SUBJECT: COMANCHE PEAK STEAM ELECTRIC STATION (CPSES)  
DOCKET NOS. 50-445 AND 50-446  
ADVANCE FSAR SUBMITTAL CONCERNING CHANGES  
IN ORGANIZATIONAL STRUCTURE

The attachment to this letter provides an advance CPSES FSAR submittal for FSAR Sections 13.1, 17.1 and 17.2 to facilitate the NRC staff review of the organizational changes. Other FSAR sections and License Basis Documents may need to be updated to be consistent with these changes. These additional revisions will be completed at a future time.

1. A description/justification of the changes.
2. A copy of the "marked up" FSAR pages.

FIGURE 13.1-1

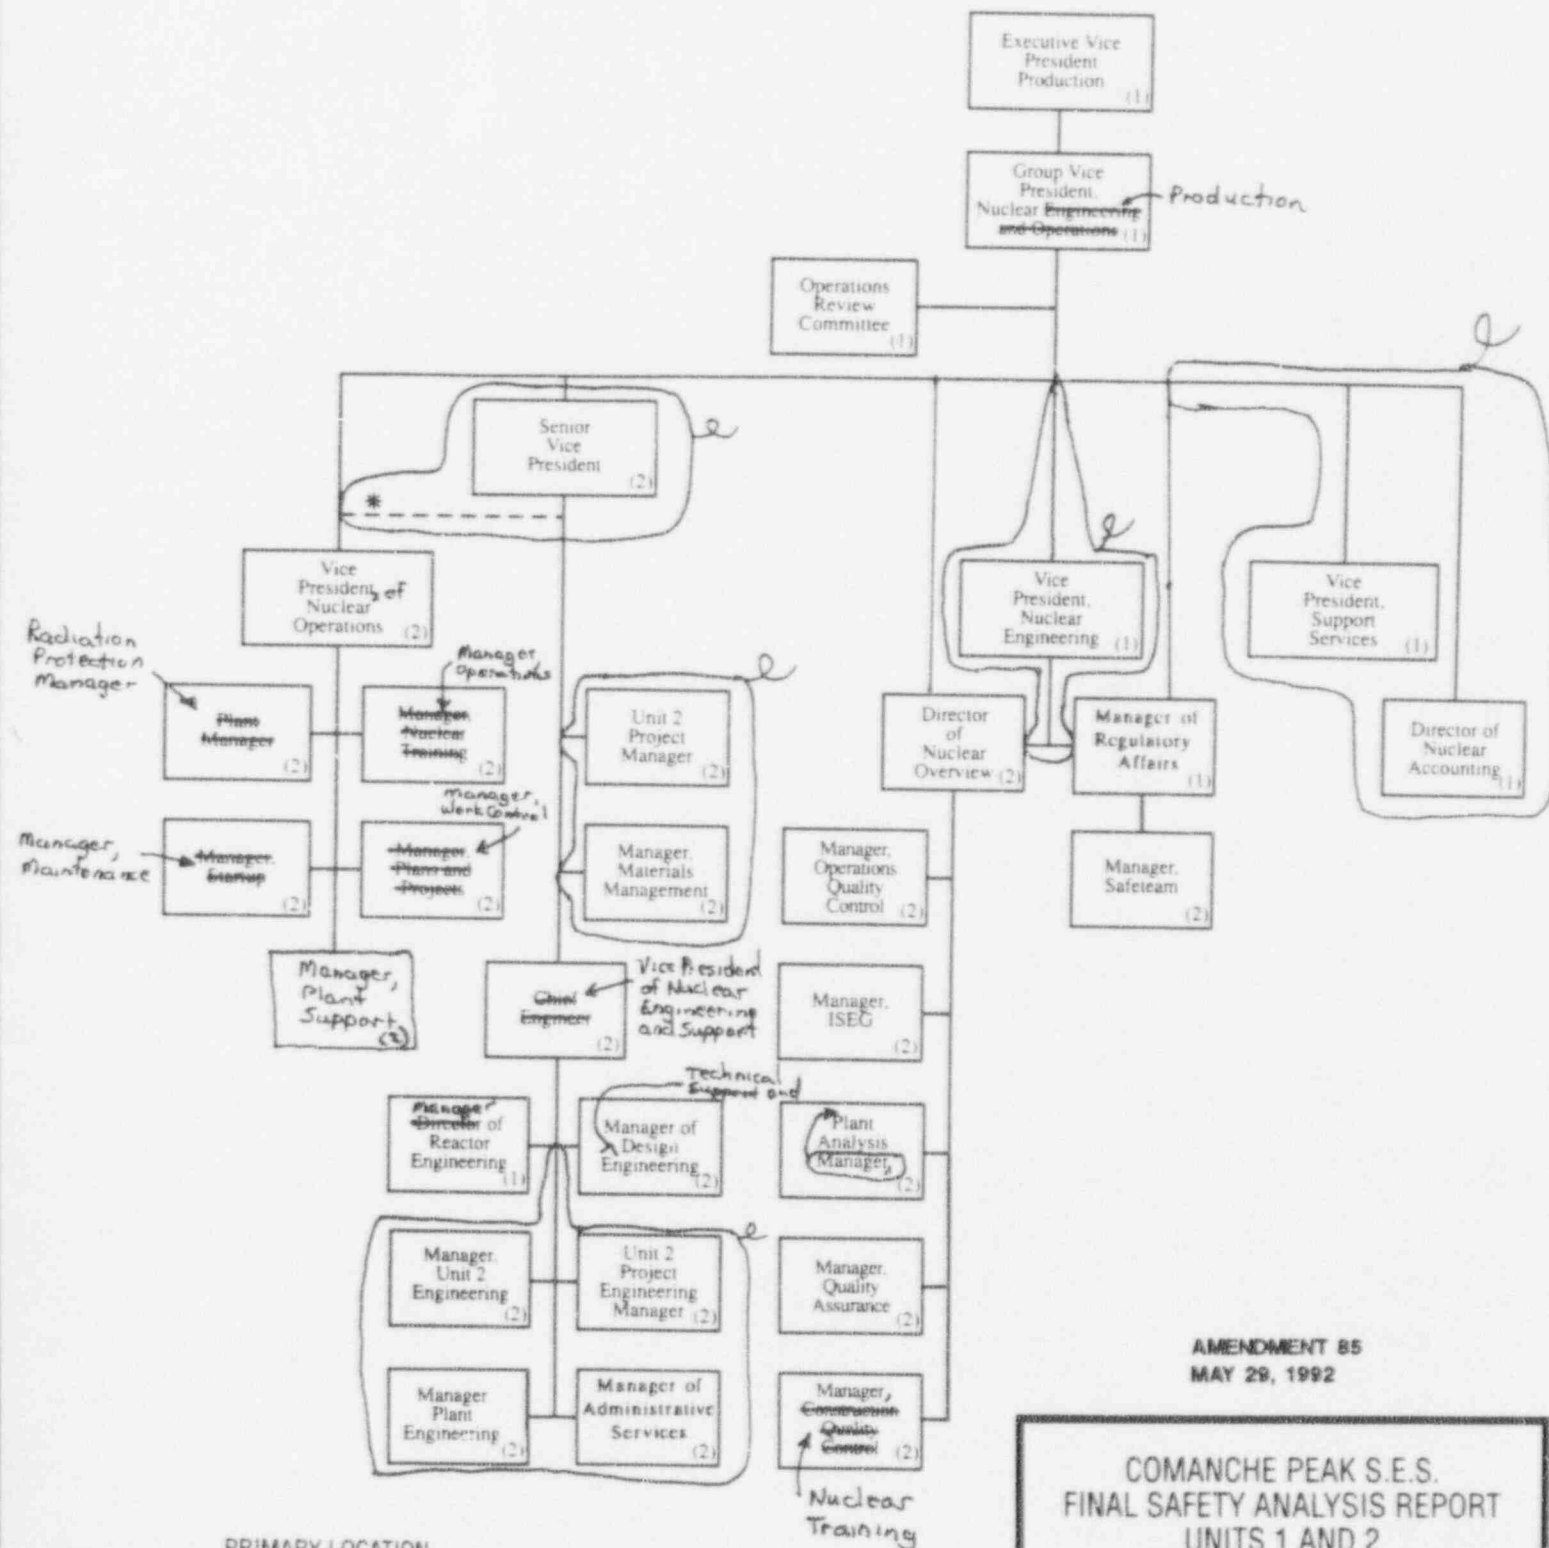
- 4 Updates description of the TU Electric corporate organizational structure.  
Update :  
See Description for p. 13.1-1.  
Change Request Number : SA-92-839.  
Commitment Register Number :  
Related SER : 13.1   SSER :25   13.1  
SER/SSER Impact : Yes  
Section 13.1 should be updated to reflect the current organizational structure.

FIGURE 13.1-2

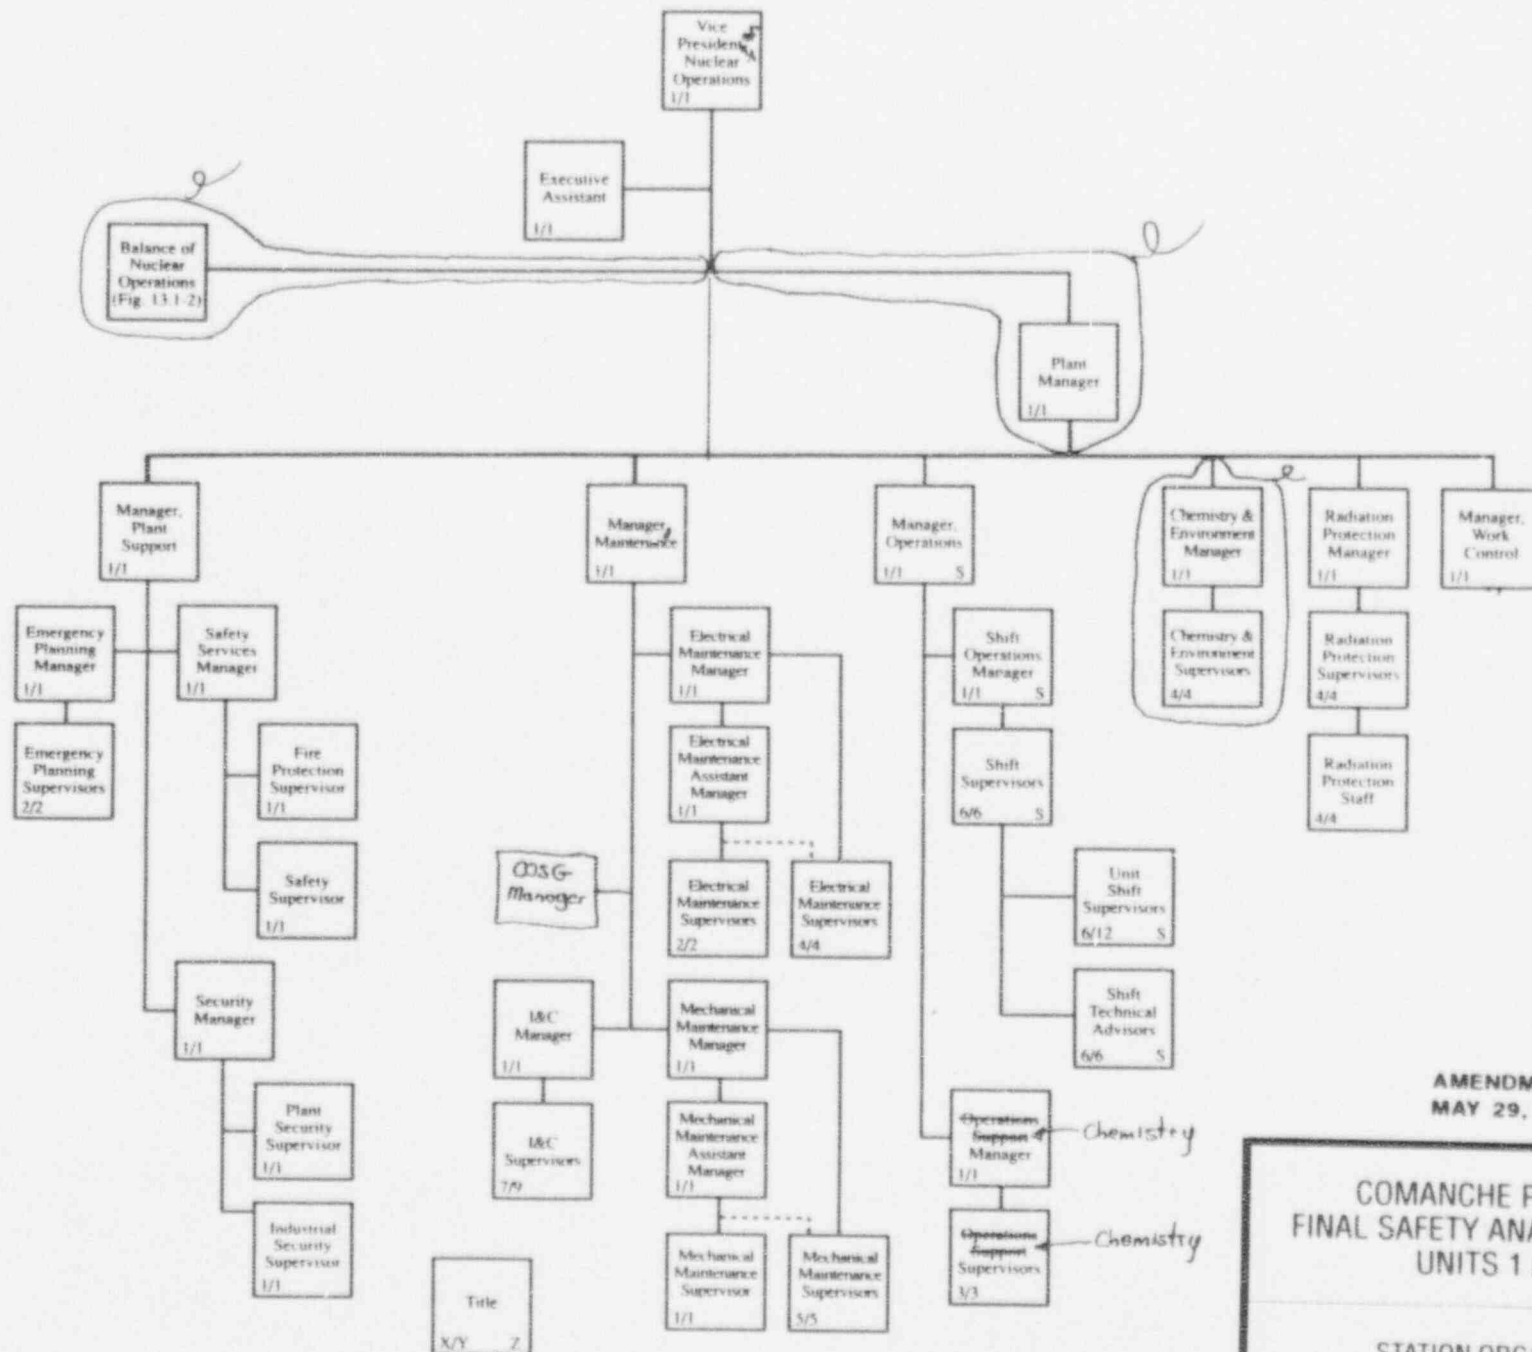
- 4 Updates the Nuclear Production Group organizational description.  
Update :  
See Descriptions for pp. 3 thru 21.  
Change Request Number : SA-92-839.  
Commitment Register Number :  
Related SER : 13.1   SSER :25   13.1  
SER/SSER Impact : No

FIGURE ~~47-1-6~~ 17.2-1

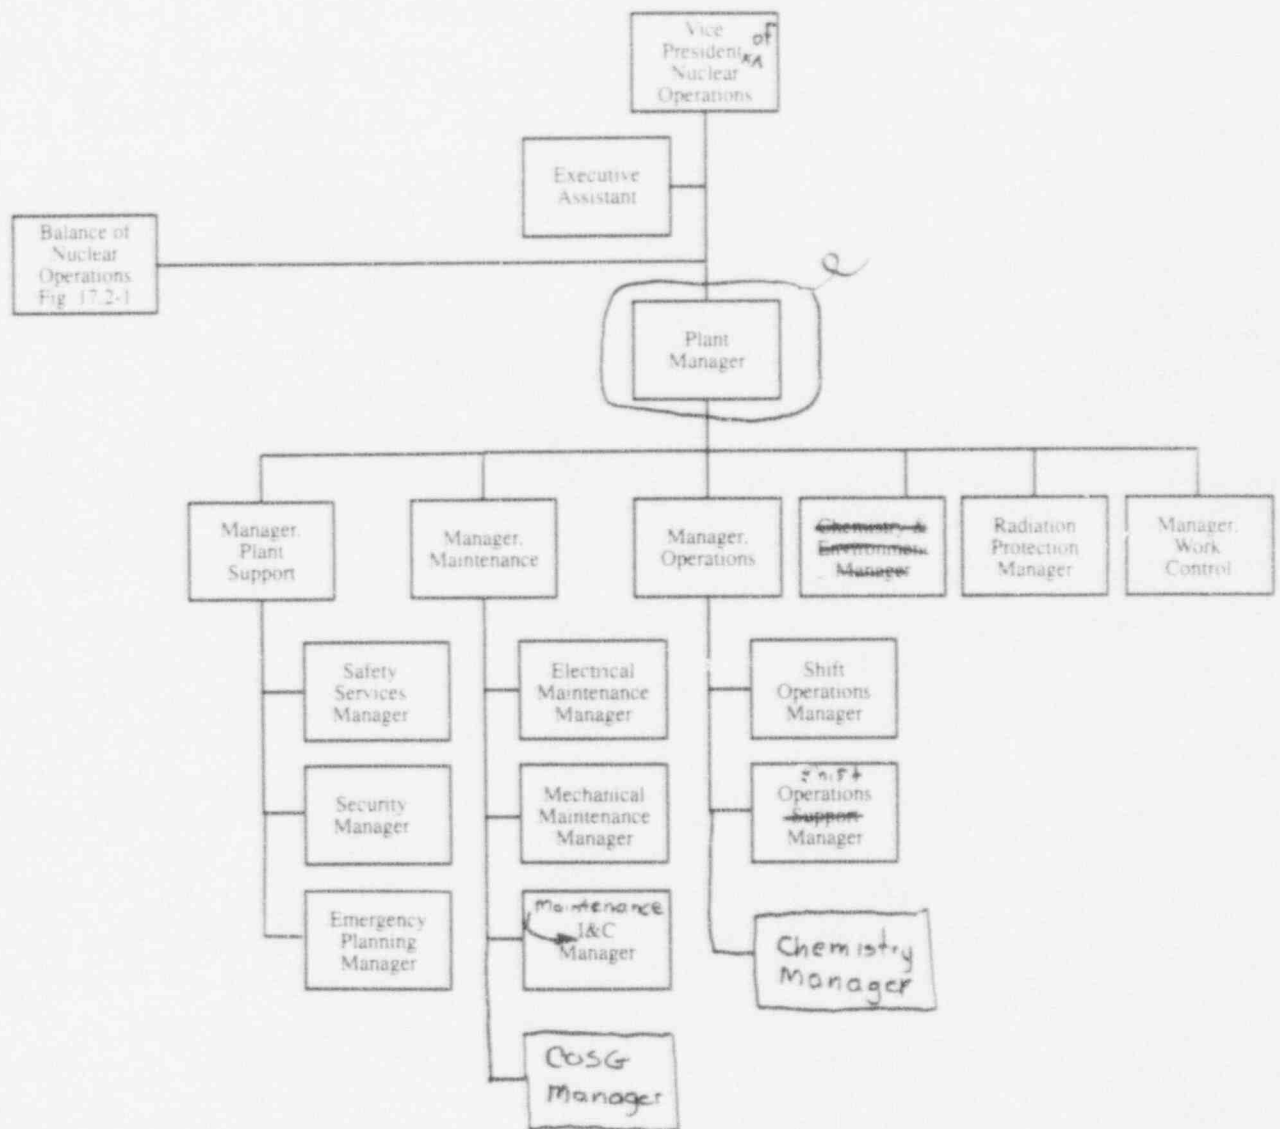
4 Provides Figure to reflect current organizational structure.

Figure 17.2-1 was deleted in a previous amendment and a reference added to see Figure 17.1-6 for the organizational structure information. However, since Section 17.1 has been deleted in its entirety,

Figure 17.1-6 has been renumbered to Figure 17.2-1 and updated to reflect the current organizational structure as described in Section 13.1.
